## ORIGINATION FORM

Proposed Revisions to a Standard Plans Index  
(Please provide all information — Incomplete forms will be returned)

Index Number: 659-010  
Sheet Number (s): 1 of 1  
Index Title: Span Wire Mounted Sign Details

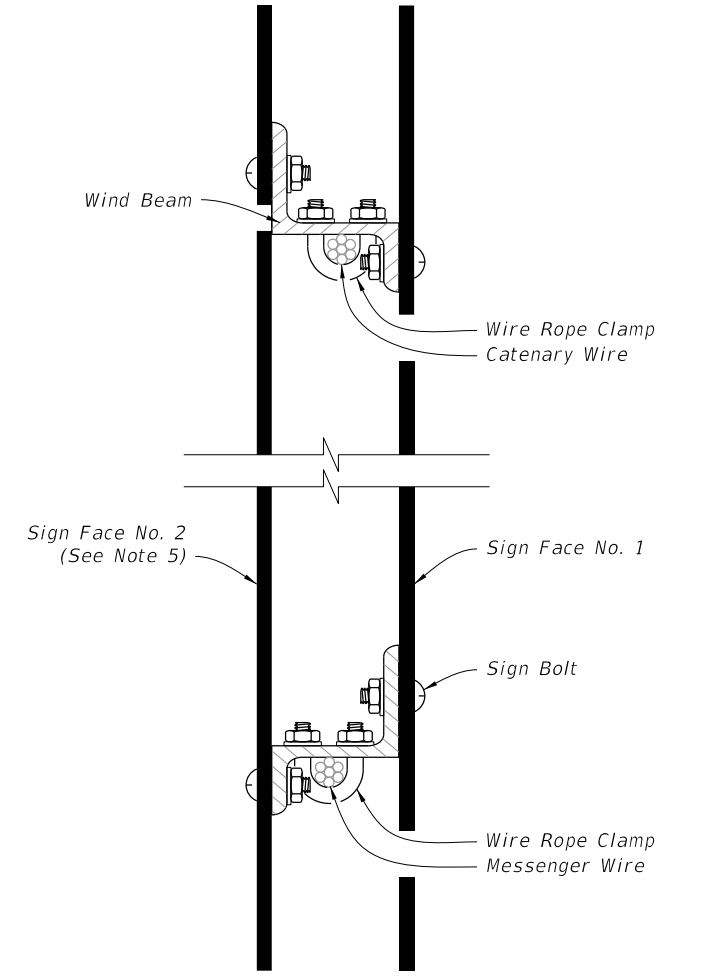
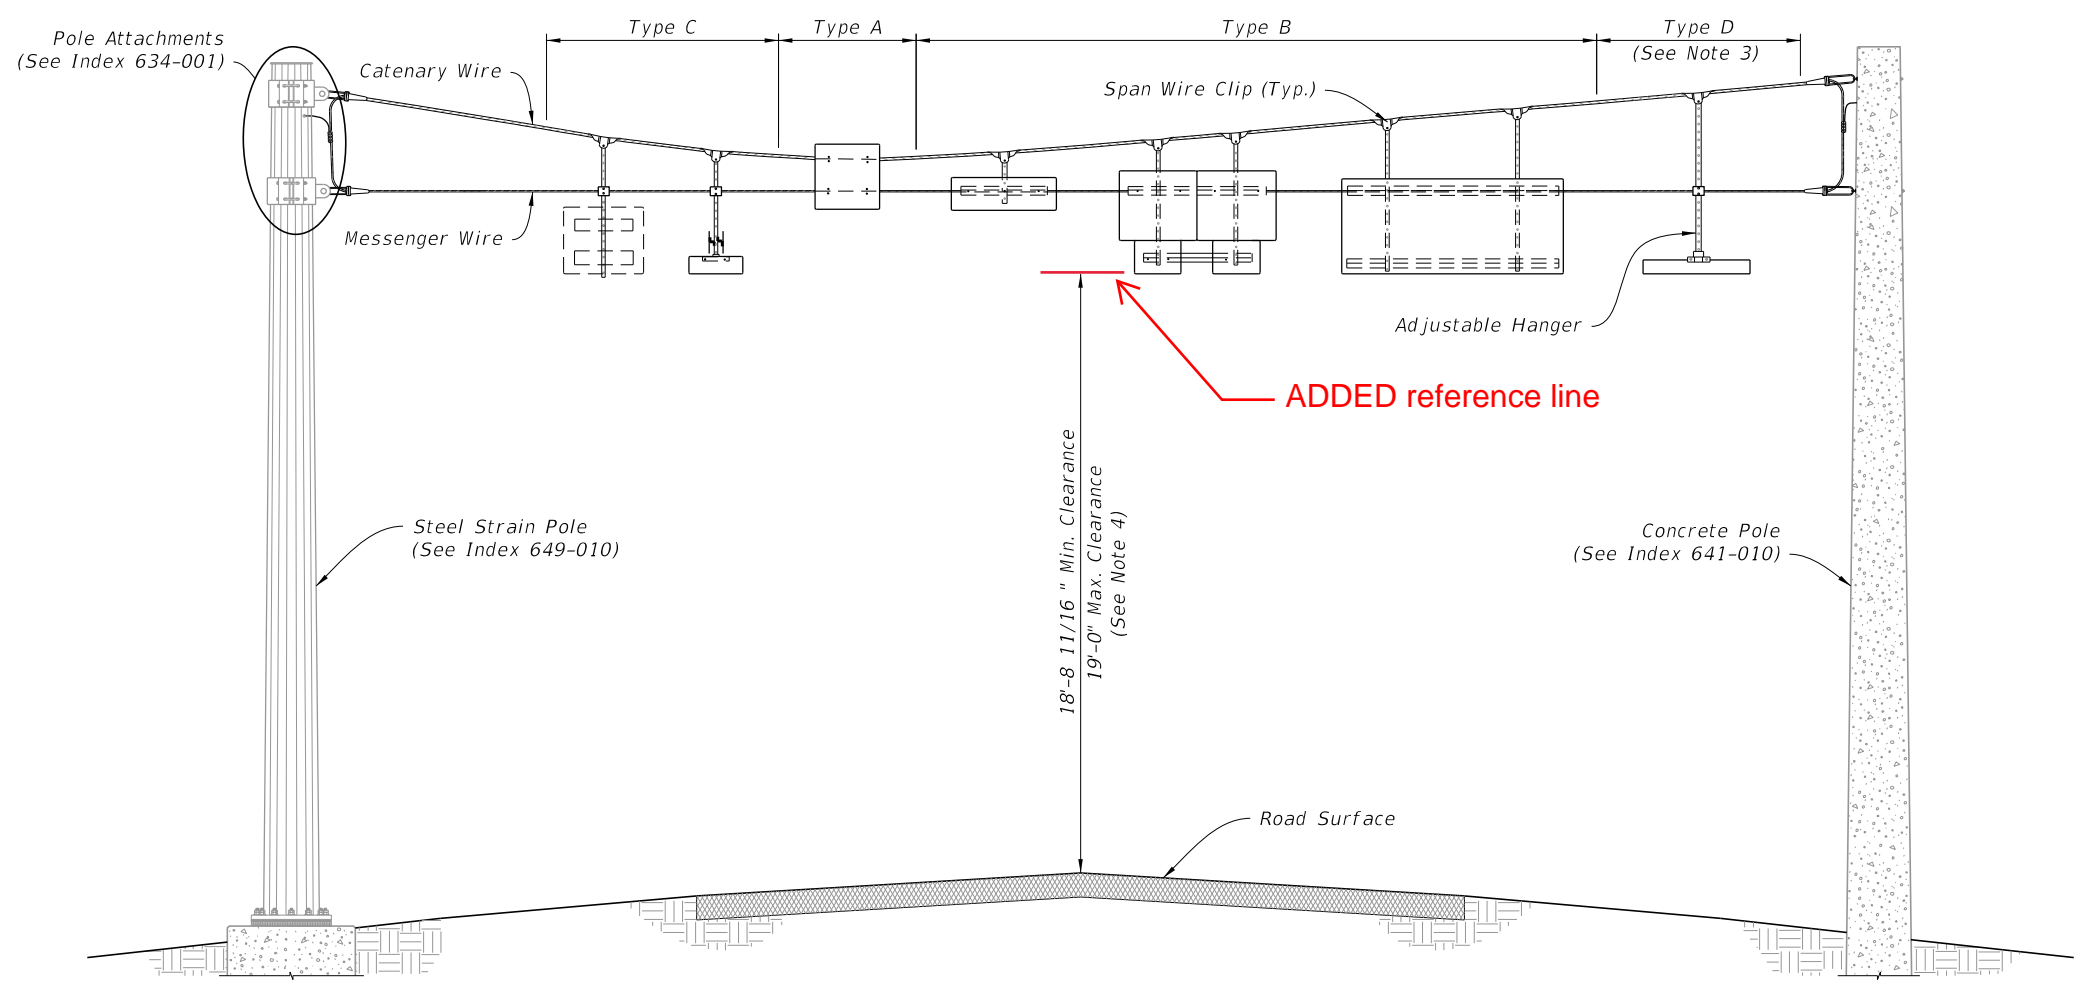
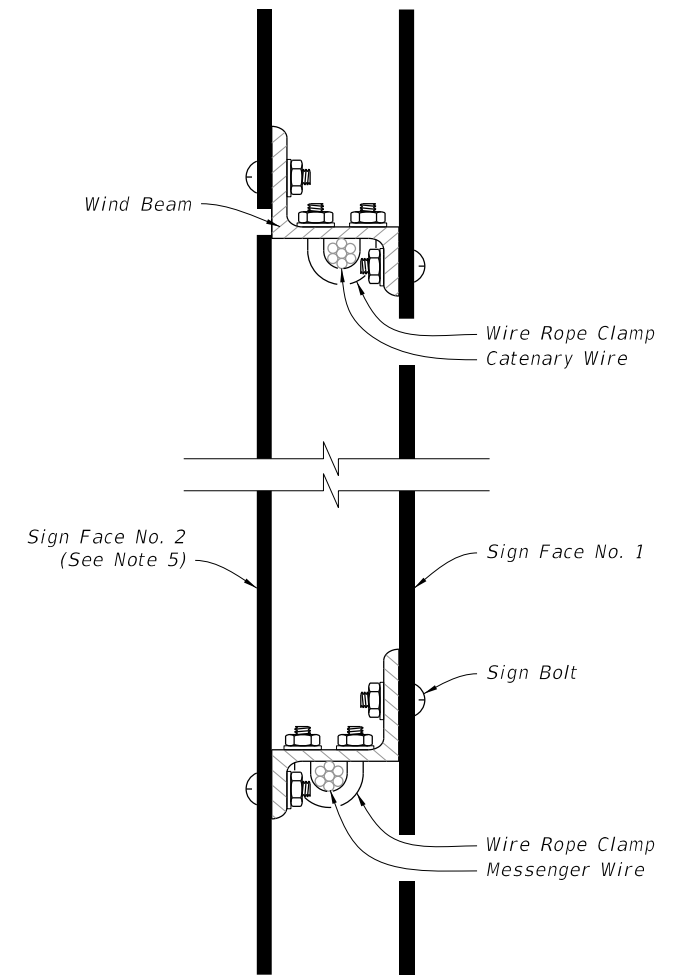
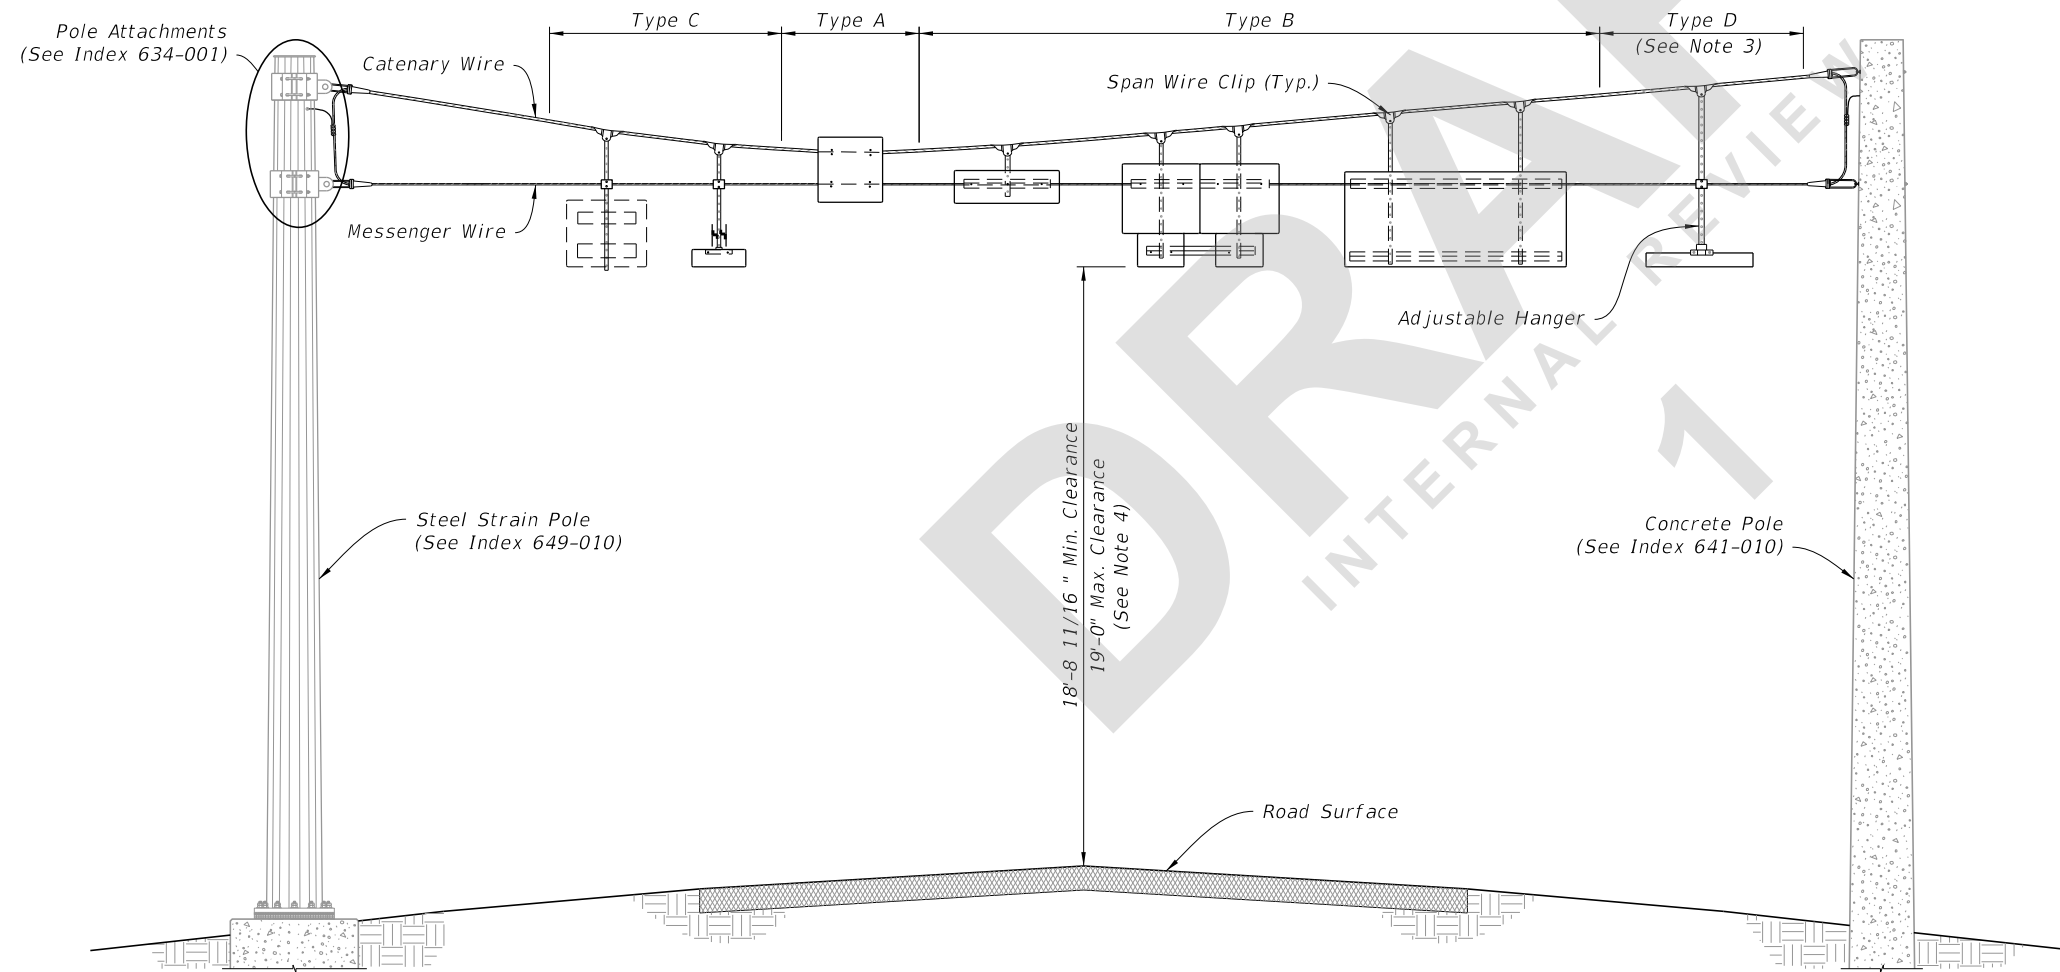
Changed Note 2.B.b. update width to greater than or equal to 8'.

This is a corrective revision to match FTP-31-06 and FTP-32-06 shown in SP Index 700-102

**CHANGED TO: 8'-0"**
